Form 3160-5
(June 2019)UNITED STATES
DEPARTMENT OF THE INTERIOR
BUREAU OF LAND MANAGEMENTFORM APPROVED
OMB No. 1004-0137
Expires: October 31, 2021**SUNDRY NOTICES AND REPORTS ON WELLS**
Do not use this form for proposals to drill or to re-enter an abandoned well. Use Form 3160-3 (APD) for such proposals.

Update casing and cement program to current design.

¹ API Number 30-025-45808	² Pool Code 96661	³ Pool Name Hardin Tank; Bone Spring
⁴ Property Code 325178	⁵ Property Name WILD WEASEL 22 FED COM	
⁷ OGRID No. 7377	⁸ Operator Name EOG RESOURCES, INC.	⁶ Well Number #715H ⁹ Elevation 3351'

Revised Permit Information 11/07/2022:

WELL LOCATION AND ACREAGE DEDICATION PLAT

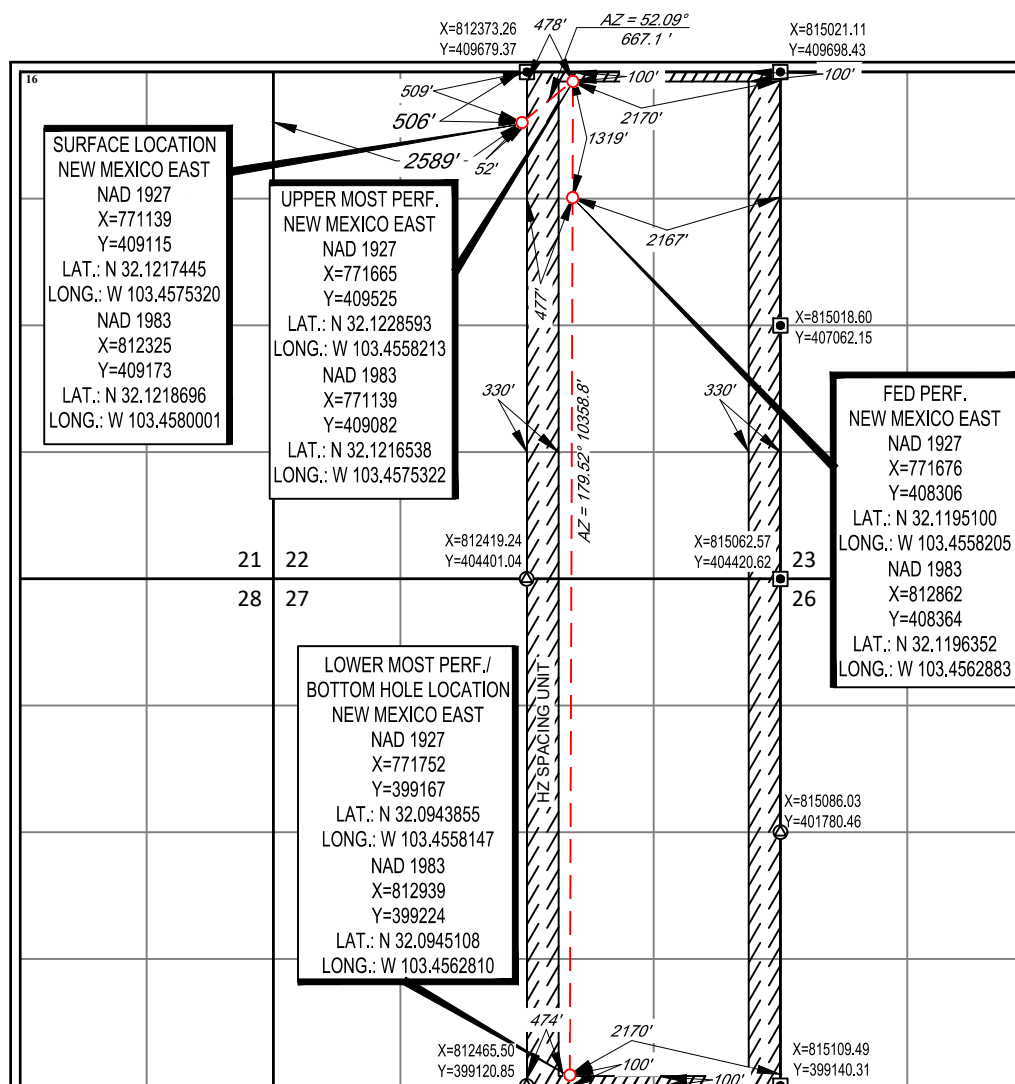
Update the Pool as reflected in the C-102.

UL or lot no.	Section	Township	Range	Lot Idn	Feet from the	North/South line	Feet from the	East/West line	County
C	22	25-S	34-E	—	506'	NORTH	2589'	WEST	LEA

UL or lot no.	Section	Township	Range	Lot Idn	Feet from the	North/South line	Feet from the	East/West line	County
0	27	25-S	34-E	—	100'	SOUTH	2170'	EAST	LEA
